CURRAGH RESOURCES INC.

SUBJECT: Dy Decline Drilling

SUBJECT: DY DECLINE DRILLING

*Dy Deposit
Underground
Decline*

975

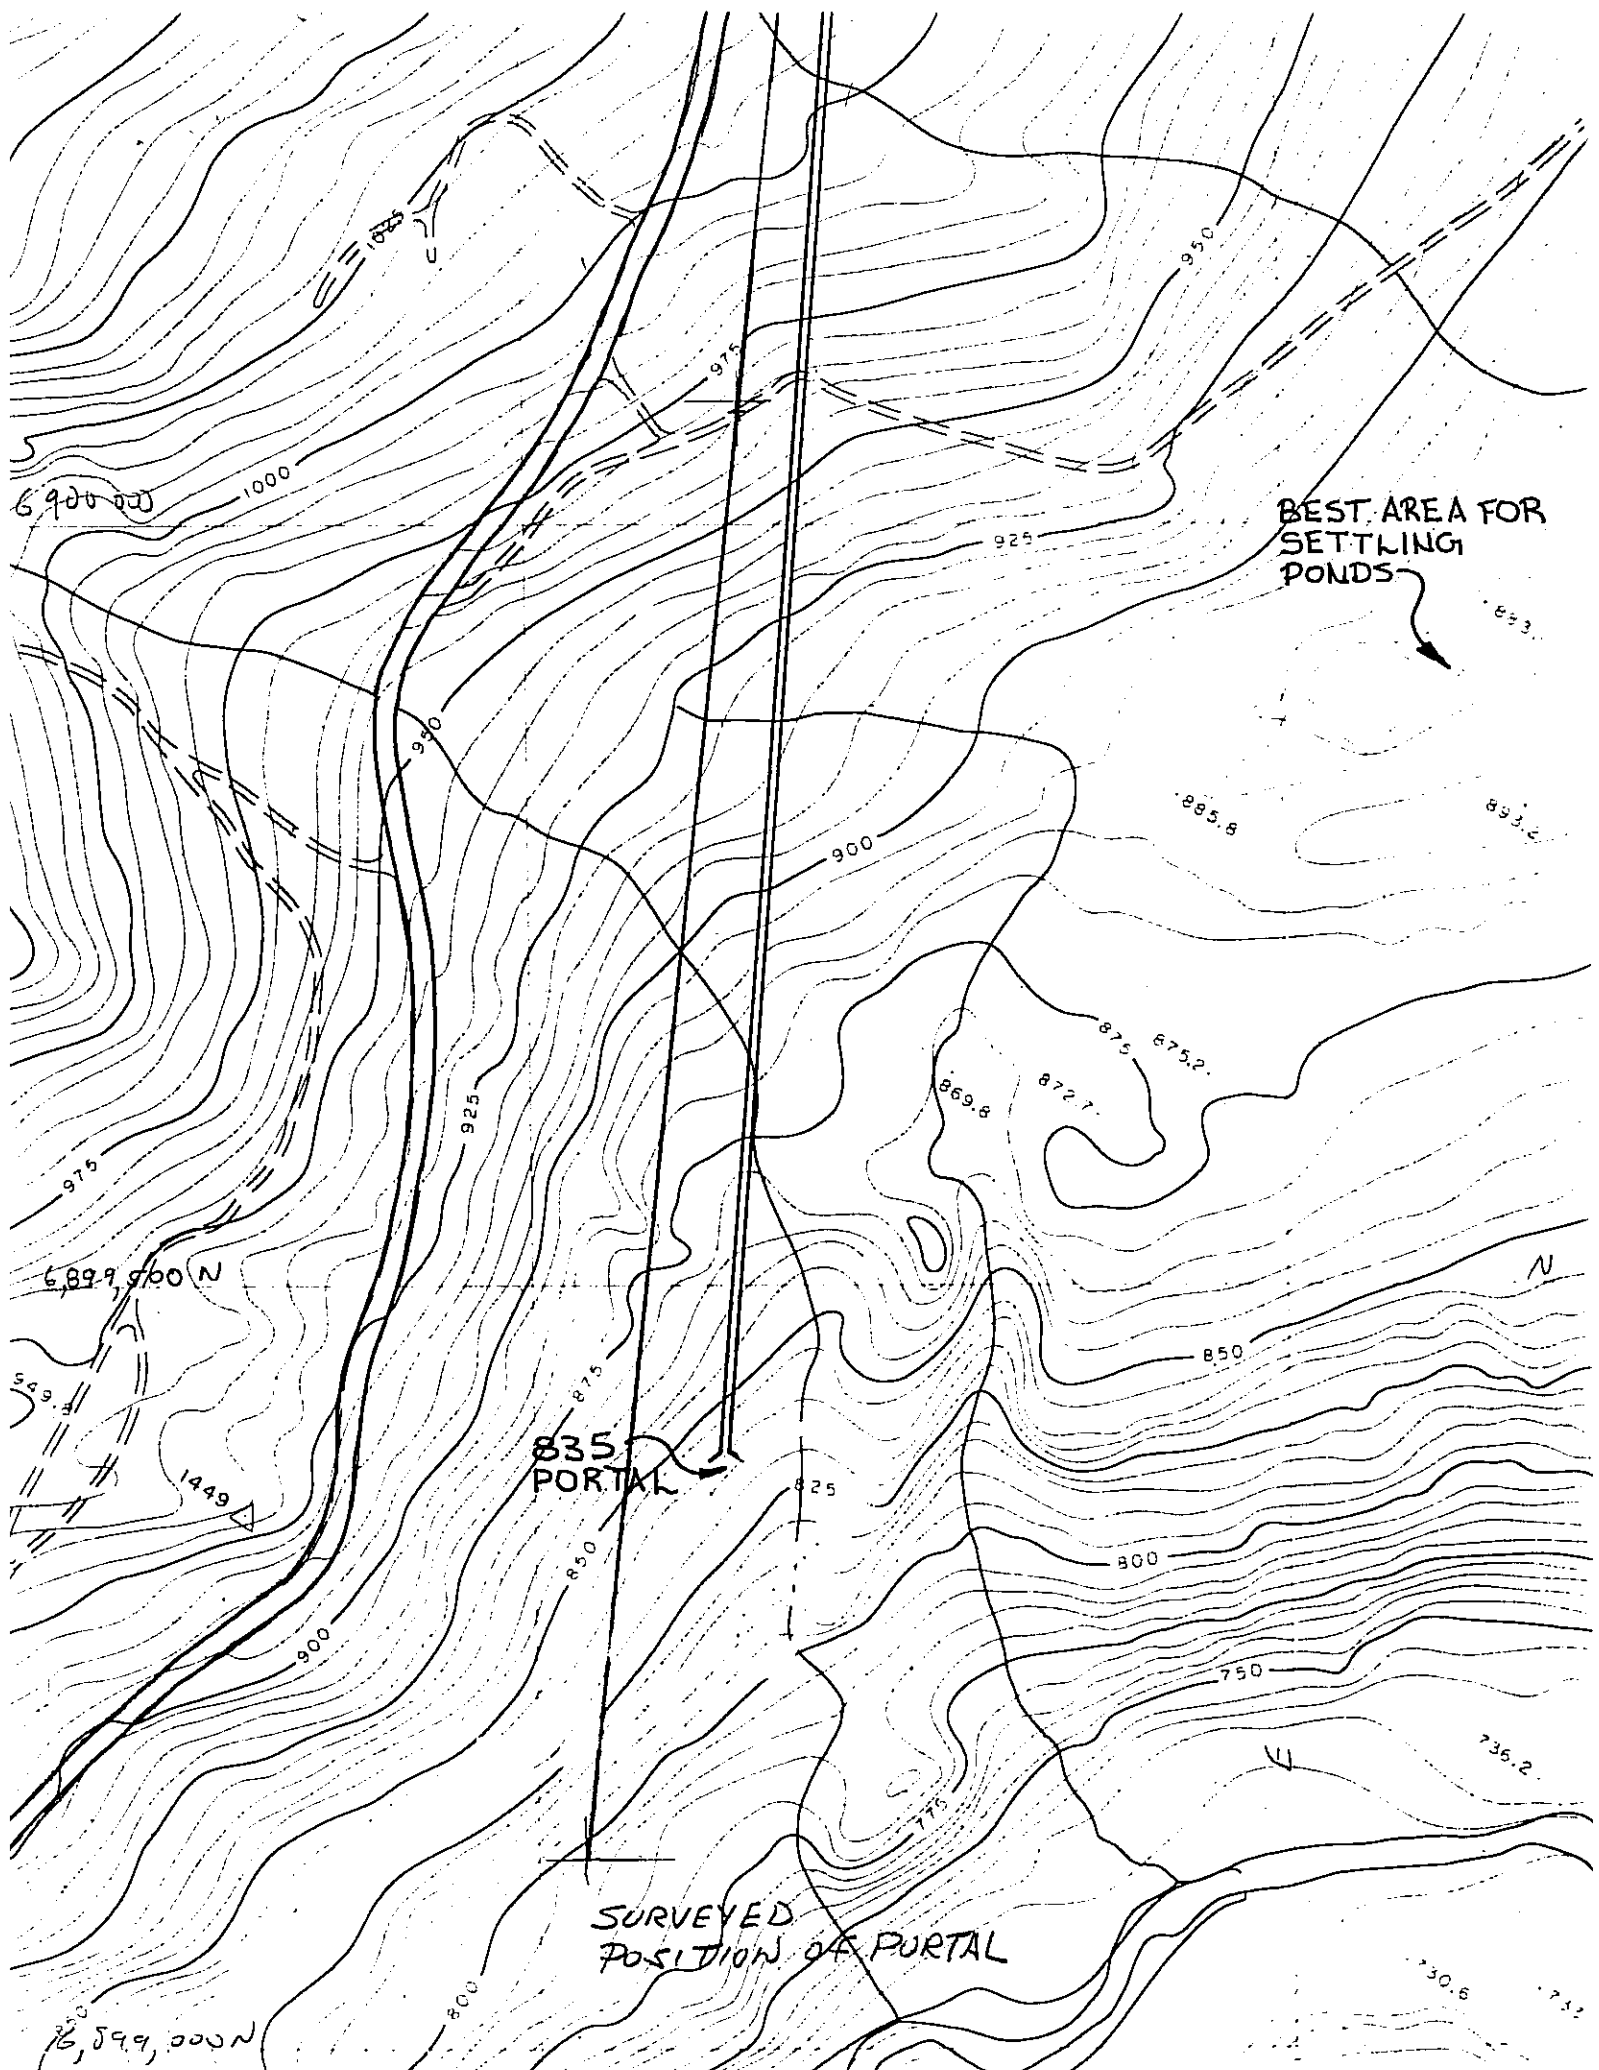
THE DECLINE, IF DONE THIS WAY WILL BE 2,064m long with a -9° plunge

THE ORIGINAL LOCATION CMD DESIGN PORTAL WAS 1,792m LONG with a -11.5° plunge

THE DIFFERENCE IS 272m or approximately three-quarters of a million dollars
OF EXTRA EXCAVATION.
